SUNDRY NOTICES AND REPORTS ON WELLS
Do not use this form for proposals to drill or to re-enter an abandoned well. Use form 3160-3 (APD) for such proposals.

8. Well Name and No.
ROSS DRAW UNIT 26

RKI Exploration and Production requests approval to recomplete the subject well in the Middle and Upper Cherry Canyon intervals.

Ross Draw Unit 26
30-015-33083
RKI Exploration & Production LLC
July 21, 2014
Conditions of Approval

PROPOSED

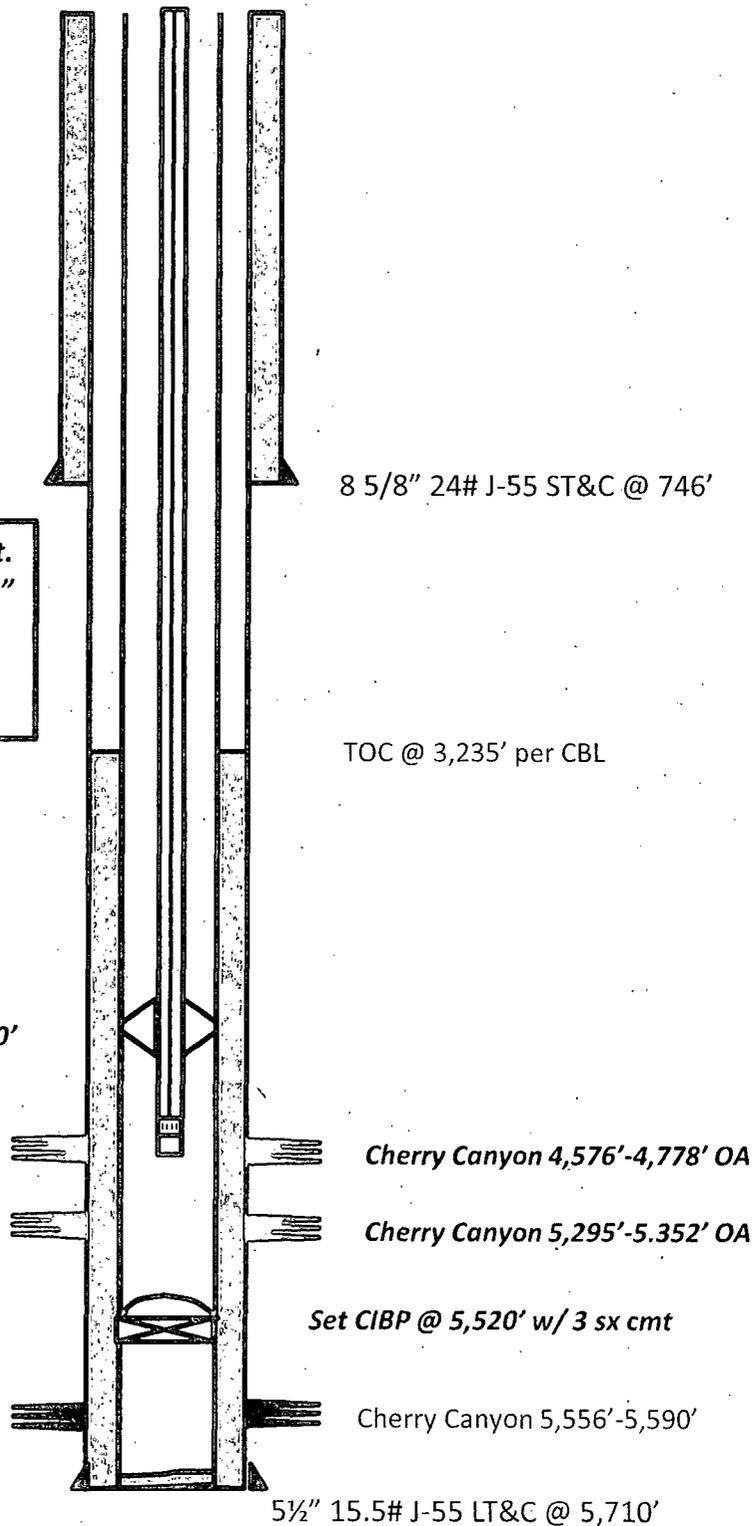
Proposed recompletion procedures: *5506*
Set 10K# CIBP at ~~5,520~~ feet. Dump bail 3 sacks cement on plug.
Perf and stimulate Middle Cherry Canyon from 5,295 feet to 5,352 feet.
Perf and stimulate Upper Cherry Canyon from 4,574 feet to 4,773 feet.
Put well on rod pump production

- 1. Operator shall set CIBP at 5,506' (50' above top most perf) with a minimum of 3sx Class C cement on top.**
- 2. Must conduct a casing integrity test before perforating and fracturing. Submit results to BLM. The CIT is to be performed on the production casing to max treating pressure. Notify BLM if test fails.**
